Product Change Notice (PCN)

PCN Number: **PCN-0451148R-01**

Product(s) Affected: PJ-037A

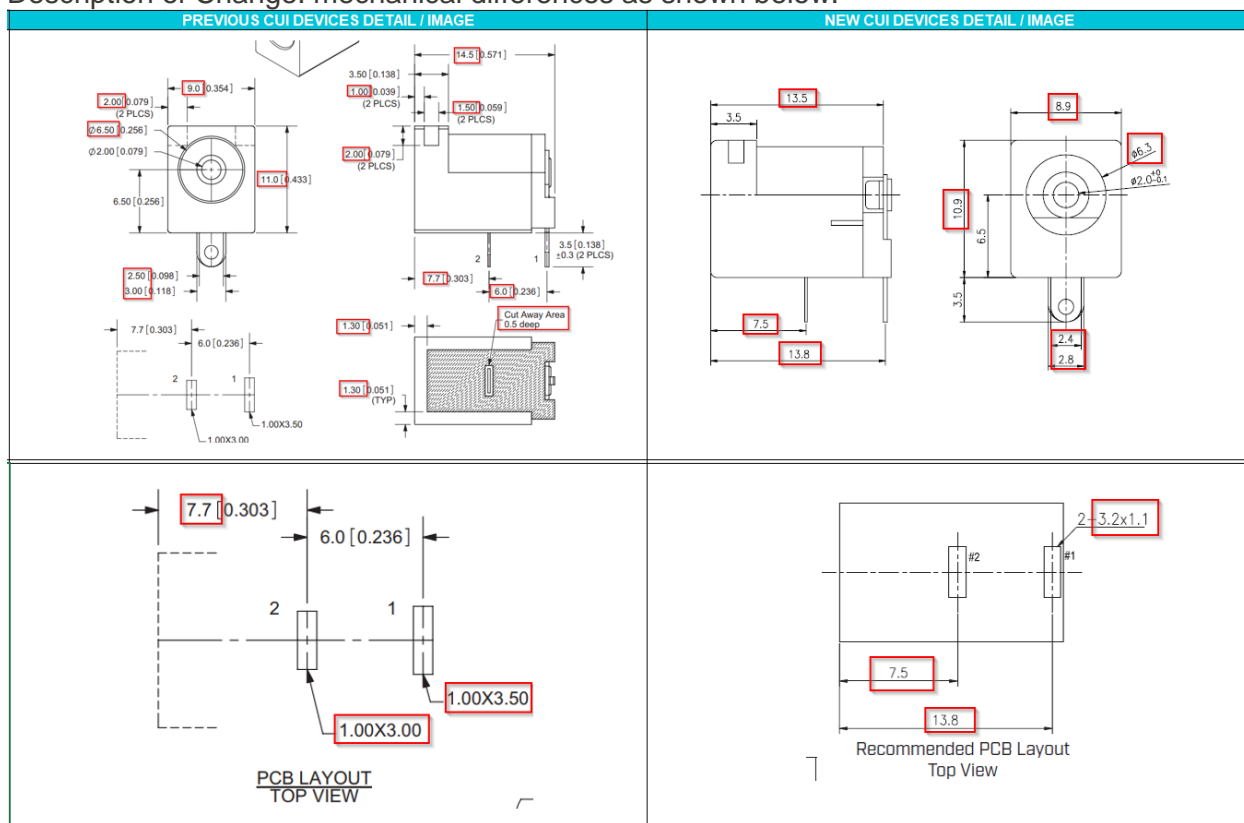
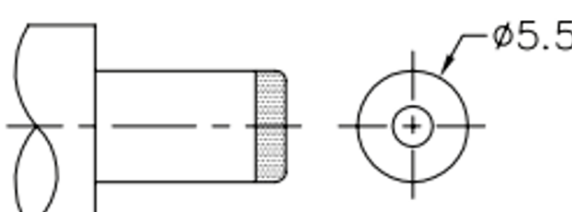
Description of Change: mechanical differences as shown below:

MATERIAL	PLATING
center pin	copper	nickel
terminal 1	brass	tin
terminal 2	copper alloy	tin
plastic	PBT

DESCRIPTION	MATERIAL	PLATING/COLOR
center pin	copper alloy	nickel
terminal 1	brass t=0.3 mm	nickel-silver
terminal 2	phosphor bronze t=0.3 mm	nickel-silver
housing	PBT (UL94V-0)	black
cover	PBT (UL94V-0)	black

MATING PLUG
Jack Insertion Depth: **9.0 mm**

MATING PLUG
Jack Insertion Depth: **9.8 mm**

Insertion/extraction force adjusted to 0.3 ~ 2.0 kg
